City of Ketchum
Planning & Building

STAFF REPORT
KETCHUM PLANNING AND ZONING COMMISSION
MAY 28, 2024 MEETING

PROJECT: 490 Wood River Dr Residence

REQUEST: Floodplain Development Permit for a new 8,077 square foot residence and modification of wetland areas.

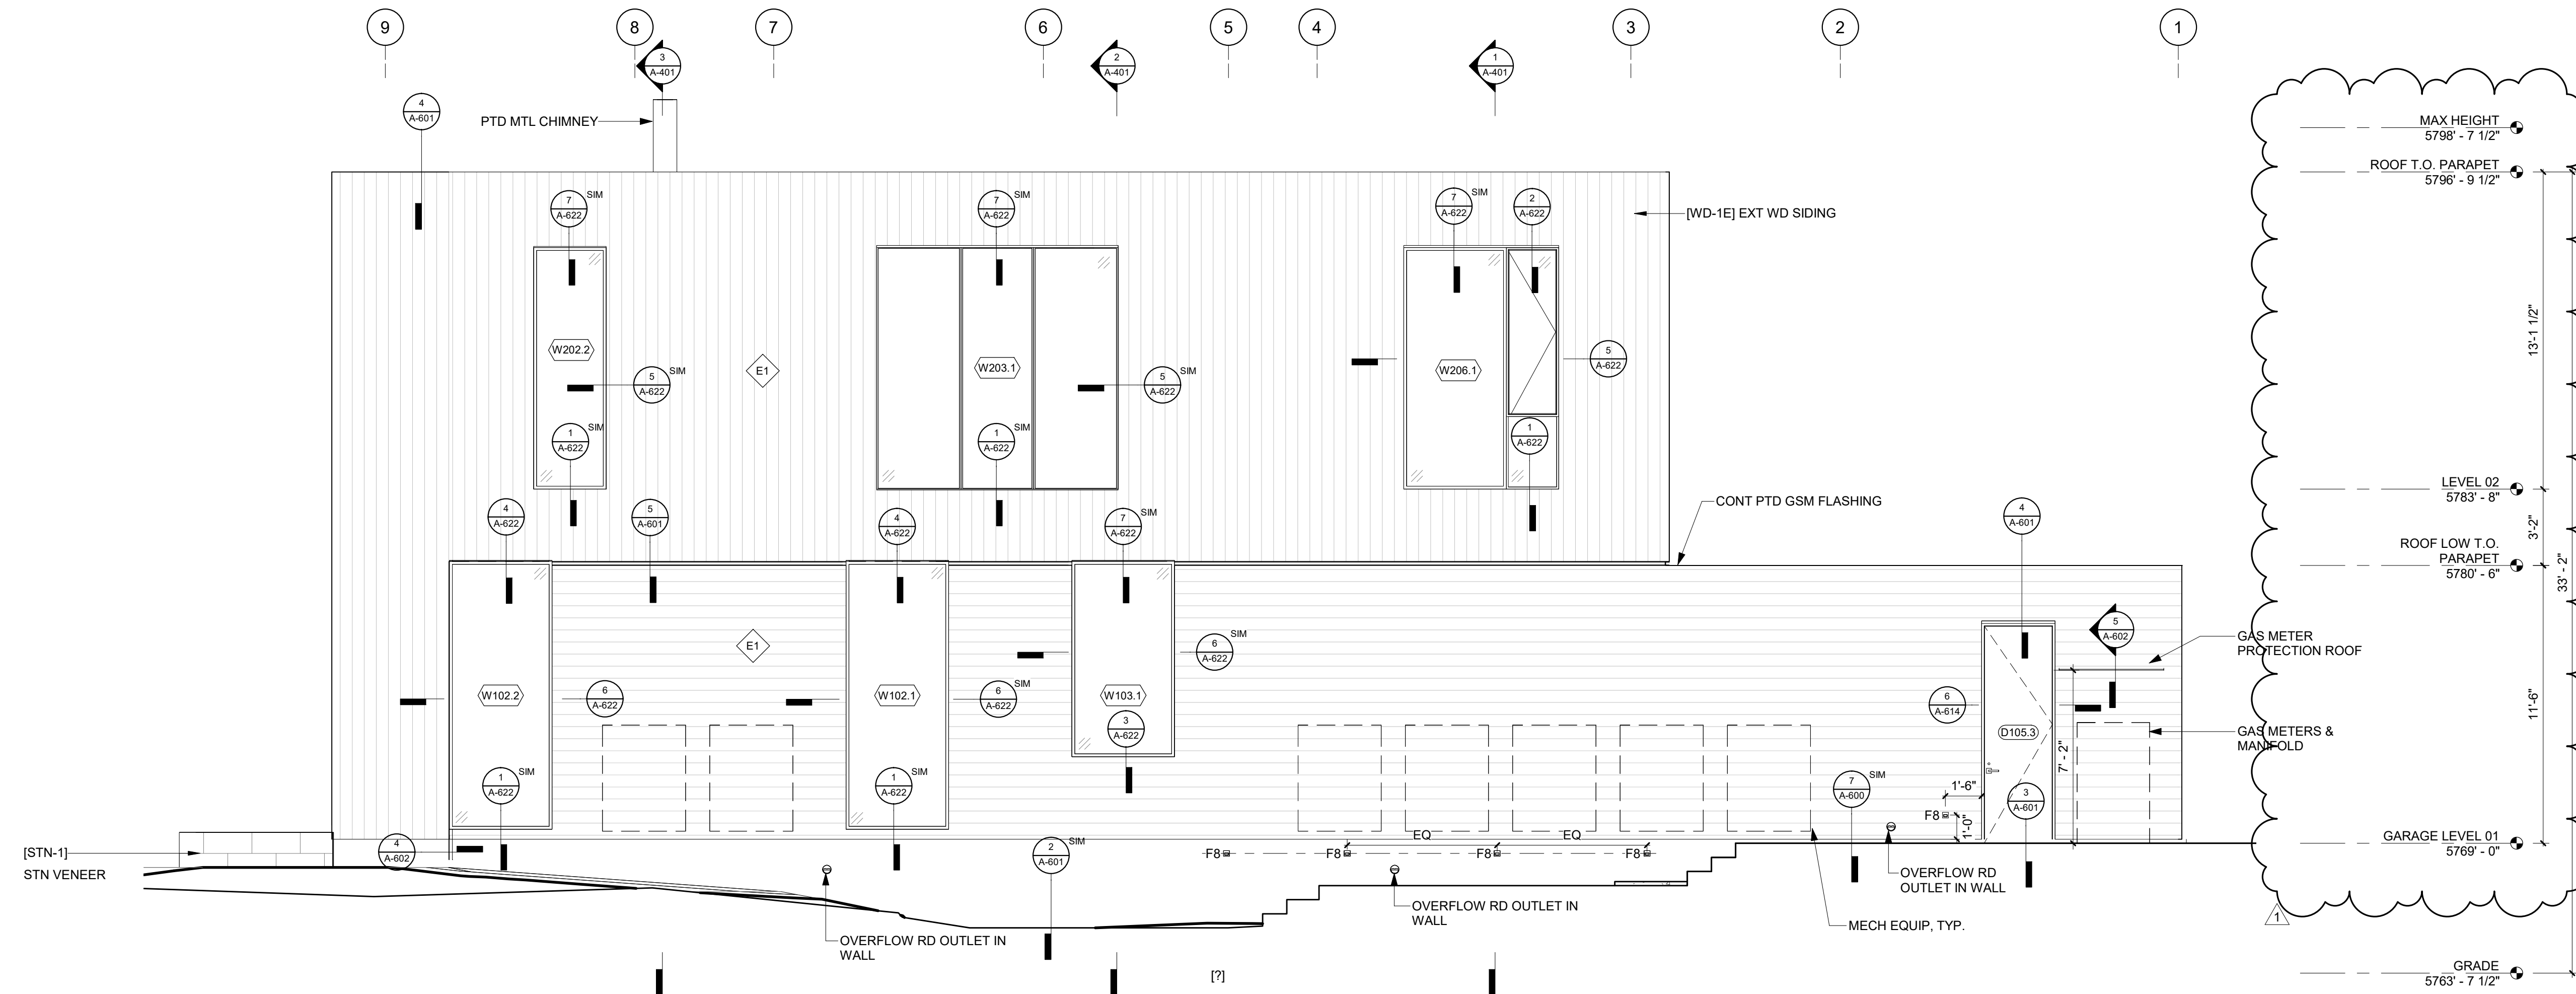
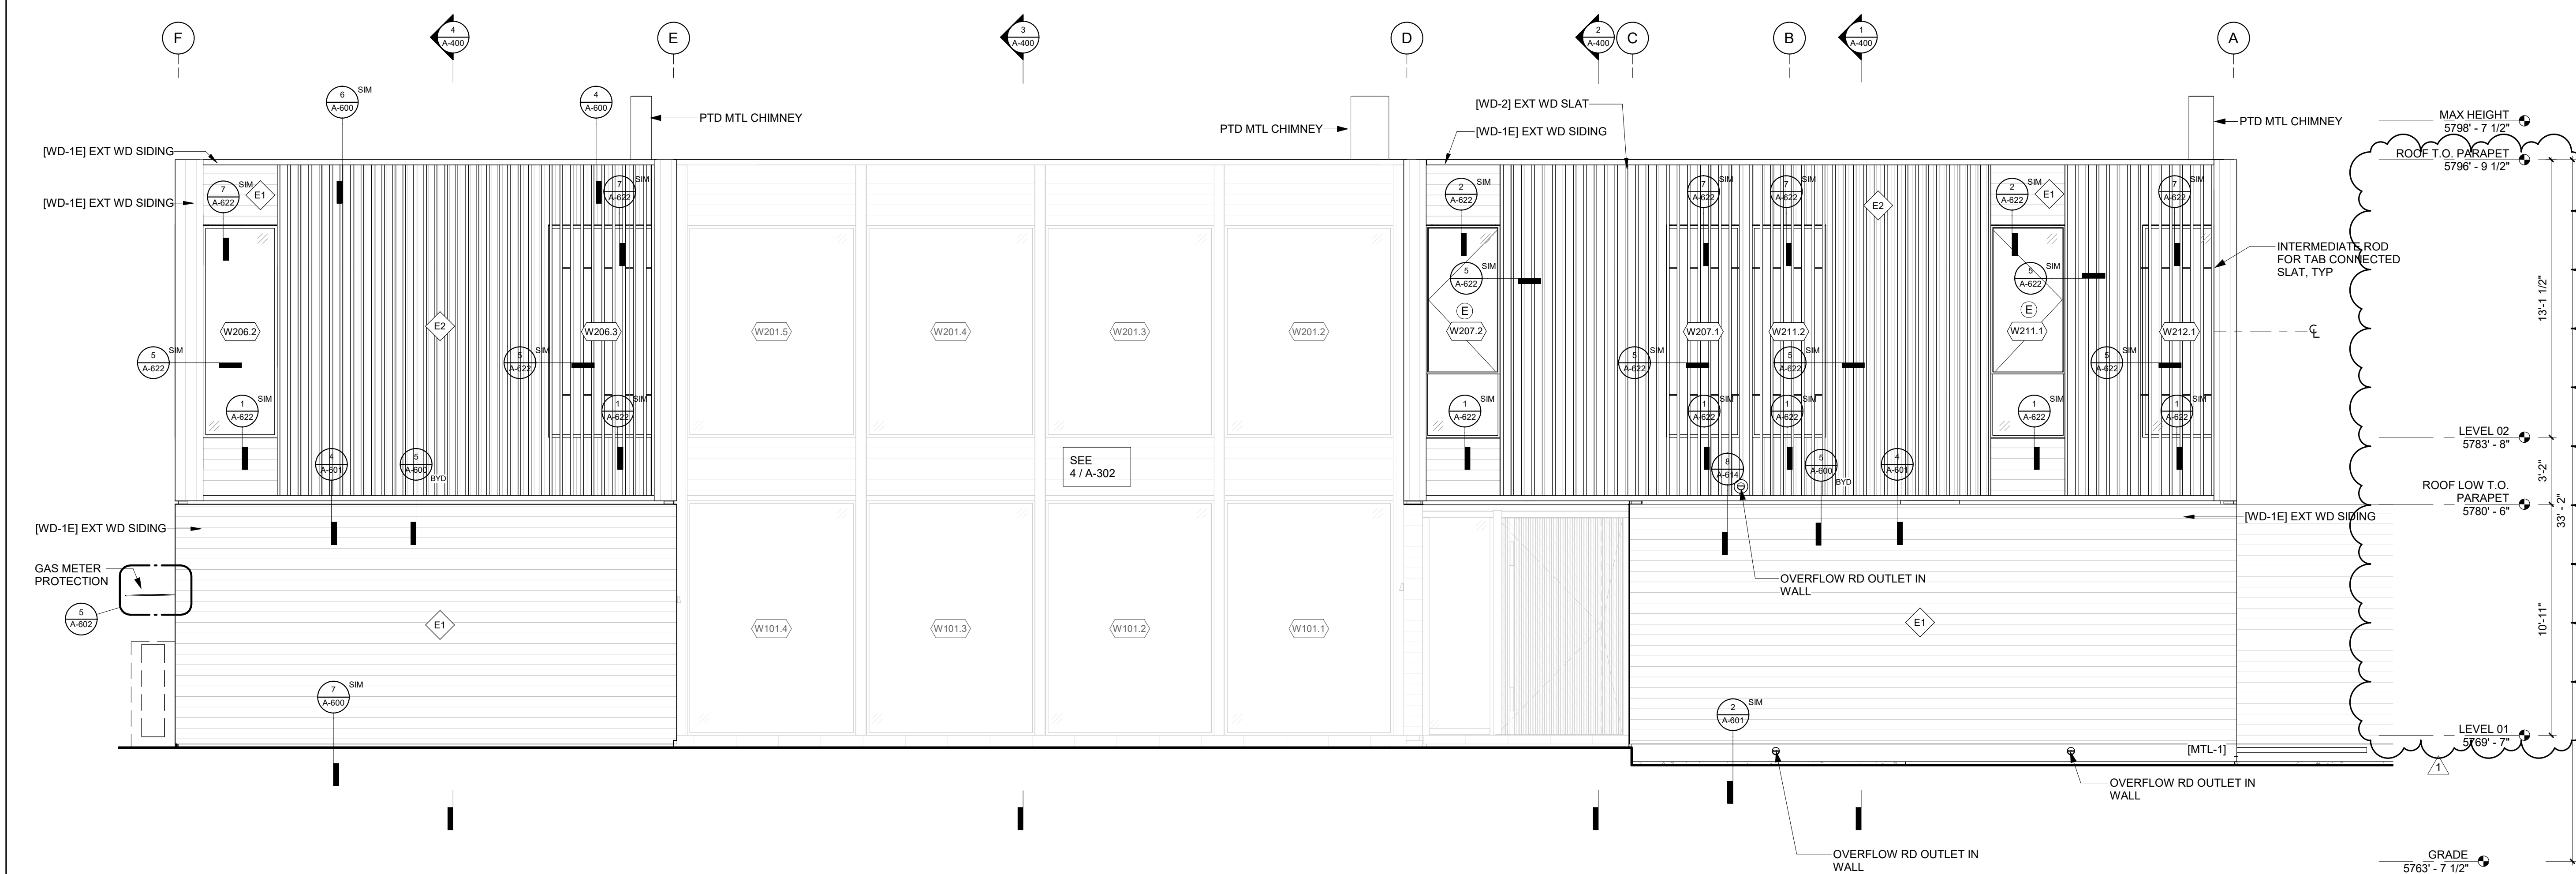
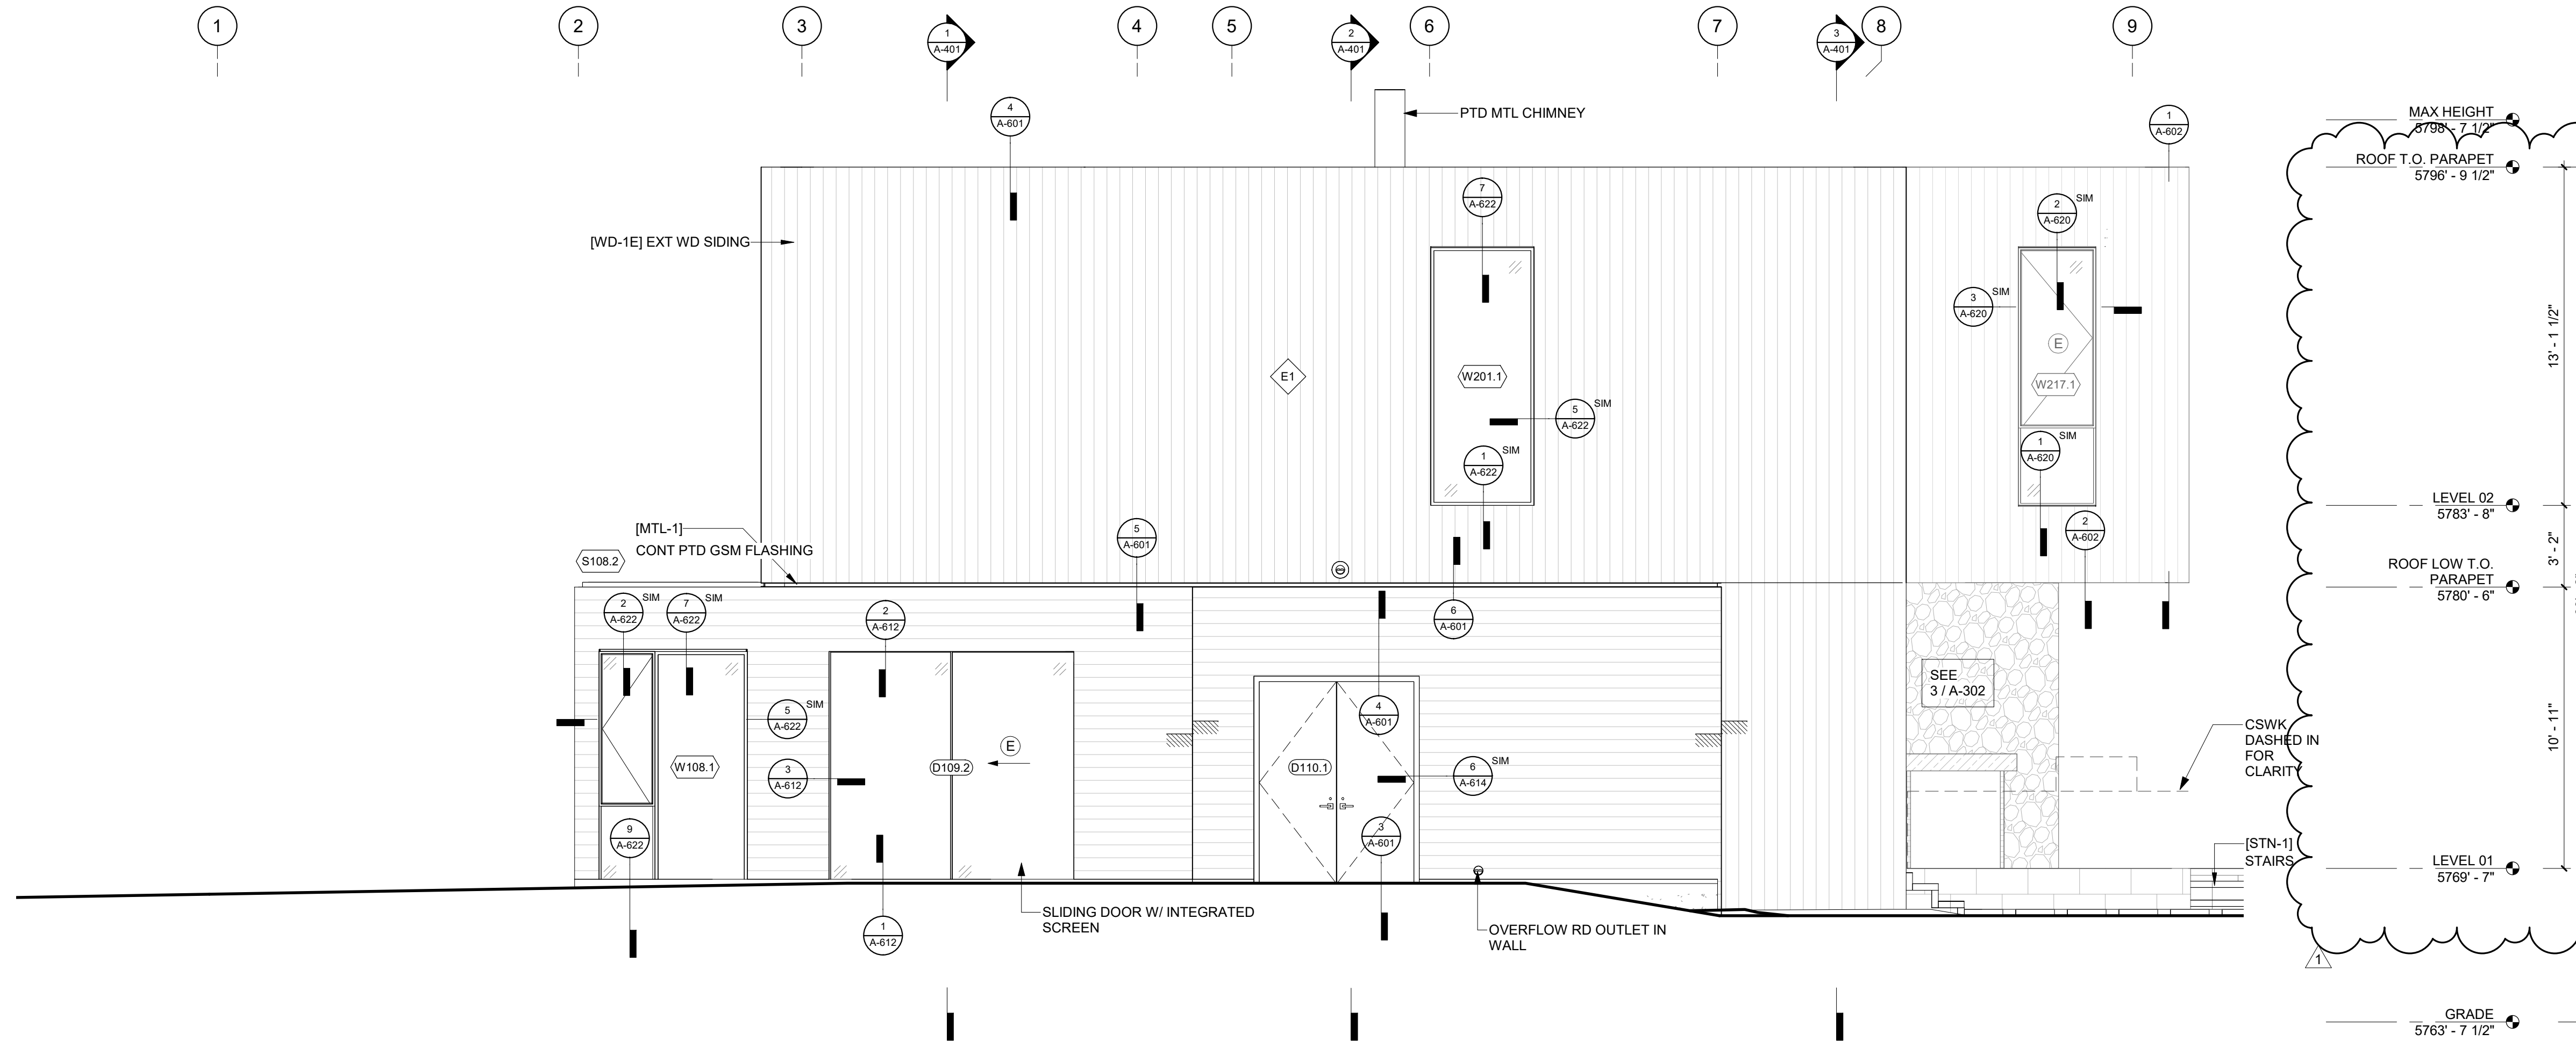
<i>Staff Comments</i>	<i>The top of the lowest floor (finished floor) is elevated 24" above the Base Flood Elevation of 5766.95 as shown on Sheets A-400 & A-401. As the proposed elevation is located within the AE zone the top of the lowest floor is required to be 24" above the BFE.</i>
<input checked="" type="checkbox"/>	<input type="checkbox"/>	<input type="checkbox"/>	17.88.050(E)10	<p>The backfill used around the foundation in the SFHA floodplain shall provide a reasonable transition to existing grade but shall not be used to fill the parcel to any greater extent.</p> <p>a. Compensatory storage shall be required for any fill placed within the floodplain.</p> <p>b. A CLOMR-F shall be obtained prior to placement of any additional fill in the floodplain.</p>
			<i>Staff Comments</i>	<i>Backfill used around the foundation which provides a reasonable transition to existing grade is not considered as part of the compensatory storage requirement. The proposed cut on the site is 638.1 cubic yards while the proposed fill not associated with the residence is 265.4 cubic yards, resulting in a net cut-fill balance of 372.7 cubic yards. The proposed cut occurs around modified drainage channels and wetlands which are hydraulically connected to the Big Wood River.</i>
